# Groundwater Transfer Review Summary Form

Transfer/PA # T- 14794

Application: T-14794

Applicant Name: Cook Landholdings LLC

**Map**

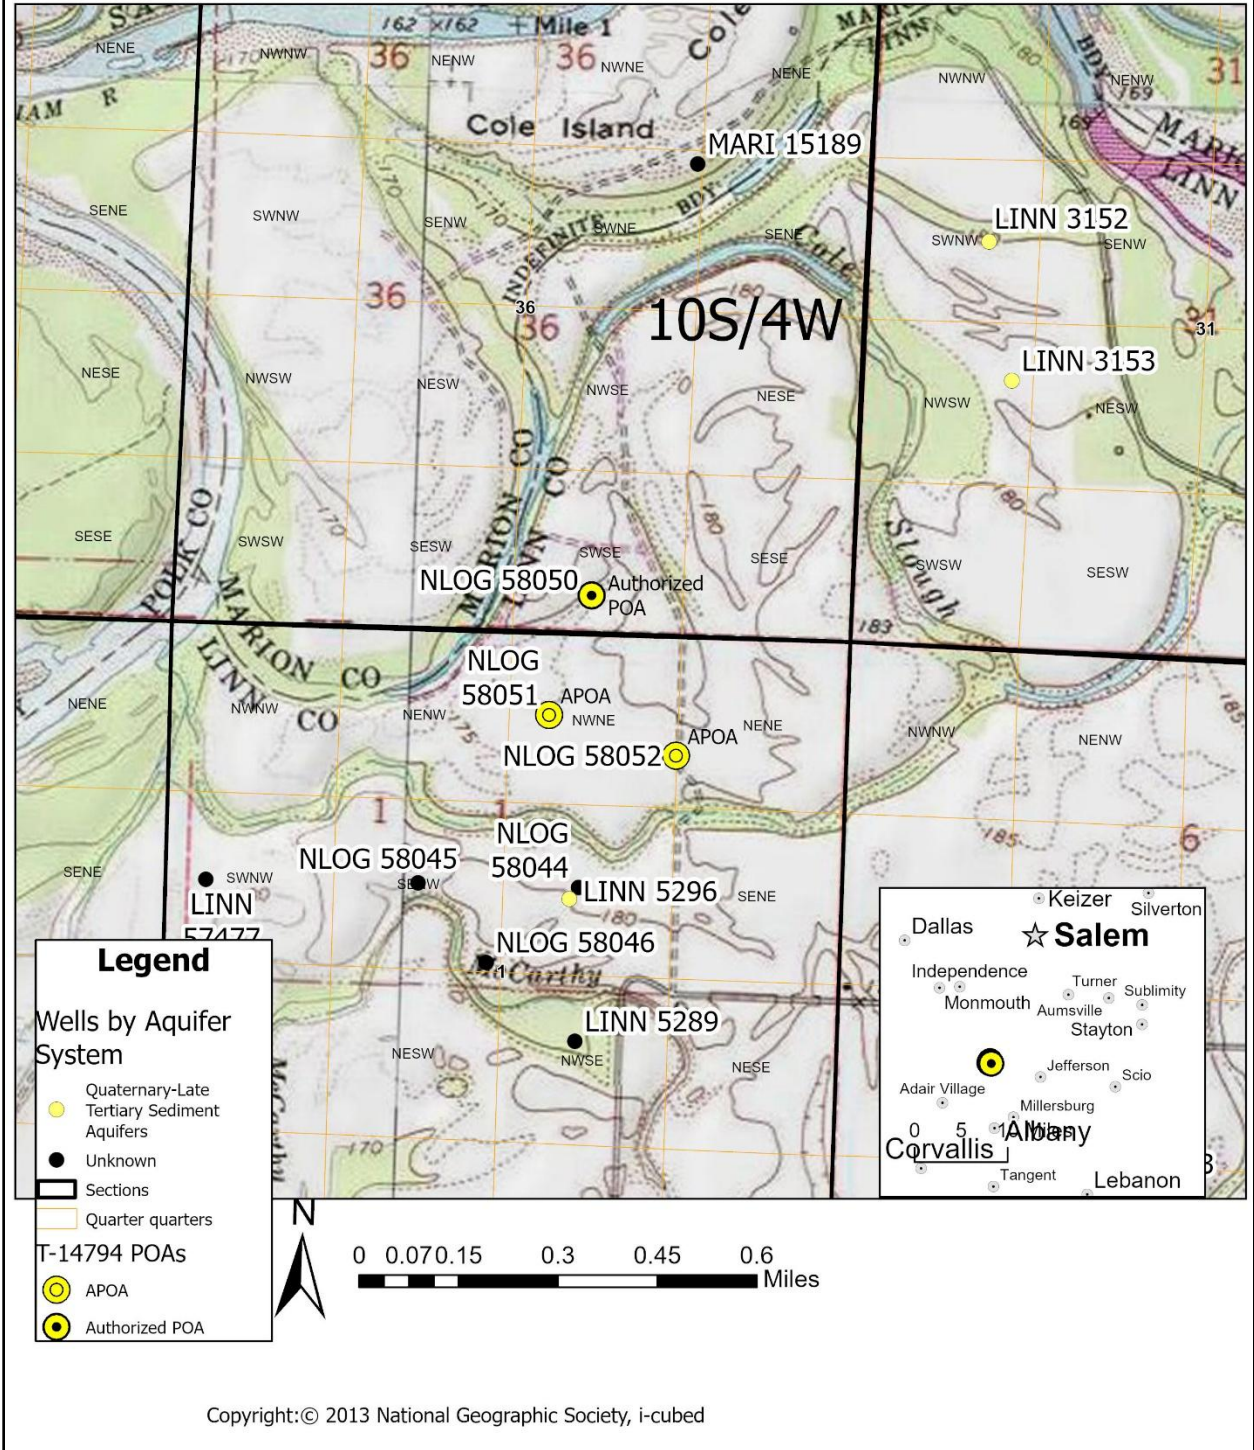
5. a) Will this proposed change, at its maximum allowed rate of use, likely result in an increase in interference with **another ground water right**?
  - Yes    No   Comments: Well 6/AB 2 (NLOG 58051) and Well 7/AB1 (NLOG 58052) are both closer to LINN 5289, a POA authorized for irrigation under Certificate 89727 with priority date 4/8/1991. The reduced intervening distance is likely to result in an increase in interference with LINN 5289.

Yes  No If yes, explain: APOA Well 7/AB1 (NLOG 58052) is 2,414 ft northeast of LINN 5289 and Well 6/AB2 (NLOG 58051) is 2,608 ft from LINN 5289. The Theis (1935) solution for drawdown was used to assess the potential for injury to LINN 5289 from the proposed changes (see attached Theis Interference Analysis). Results indicate the proposed change is unlikely to result in LINN 5289 not receiving the water to which it is legally entitled

**Well 7/AB1 (NLOG 58052)-LINN 5289 Interference Analysis**

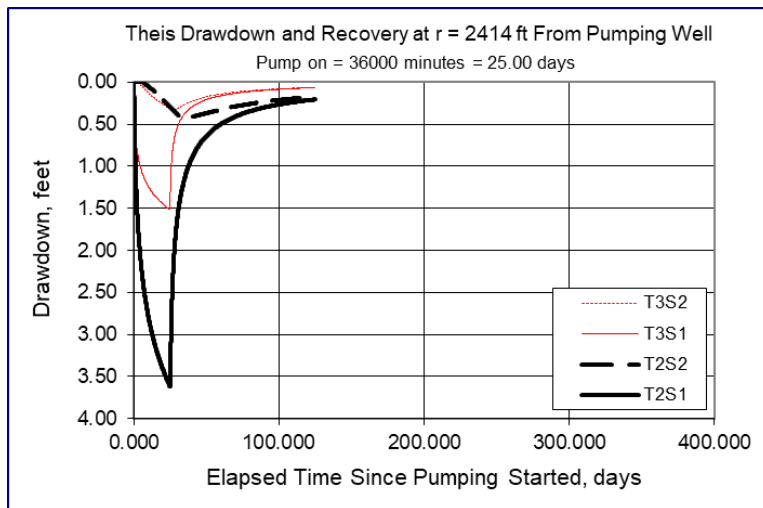
APOA Well 7/AB1 (NLOG 58052) could not pump the combined authorized rate for the full 245-day irrigation season without exceeding the assigned duties. At the full combined rate of 2.03 cfs, the authorized duty would be reached after 25 days. In addition, scenarios using T1 are not shown below as they would dewater the pumping well.

SWL	16 ft bls	Woodward et al., 1998
Aquifer Bottom	36 ft bls	Woodward et al., 1998
Available Water Column	20 ft	Aquifer bottom-SWL
Pump Height Above Bottom	5 ft	Estimate
NPSHa	5 ft	Estimate
Drawdown	4 ft	LINN 5289 Pump Test
Minimum Water Column	14 ft	Estimated Drawdown + NPSHa + Pump Height
Injury	6 ft	Available Water Column-Minimum Water Column

**Well 6/AB2 (NLOG 58051)-LINN 5289 Interference Analysis**

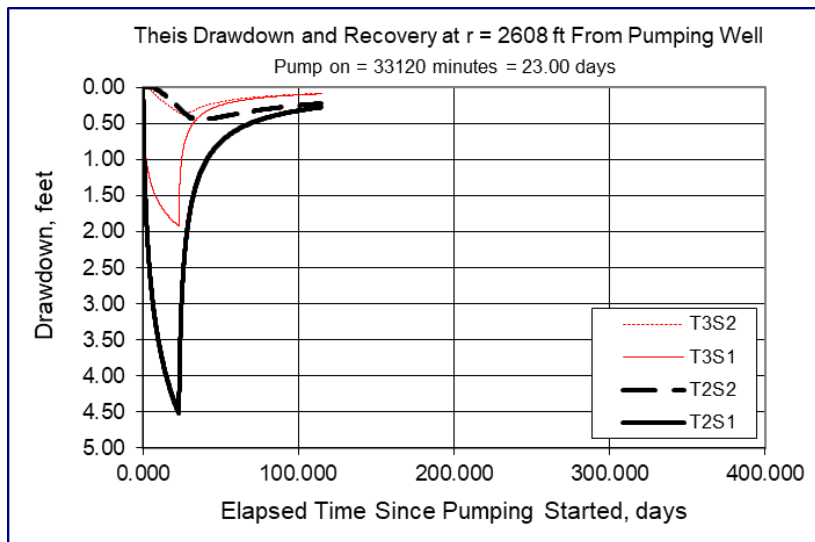
APOA Well 6/AB2 (NLOG 58051) could not pump the combined authorized rate for the full 245-day irrigation season without exceeding the assigned duties. At the full combined rate of 2.7 cfs, the authorized duty would be reached after 23 days. In addition, scenarios using T1 are not shown below as they would dewater the pumping well.

SWL	16 ft bls	Woodward et al., 1998
Aquifer Bottom	36 ft bls	Woodward et al., 1998
Available Water Column	20 ft	Aquifer bottom-SWL
Pump Height Above Bottom	5 ft	Estimate
NPSHa	5 ft	Estimate
Drawdown	4 ft	LINN 5289 Pump Test
Minimum Water Column	14 ft	Estimated Drawdown + NPSHa + Pump Height
Injury	6 ft	Available Water Column-Minimum Water Column
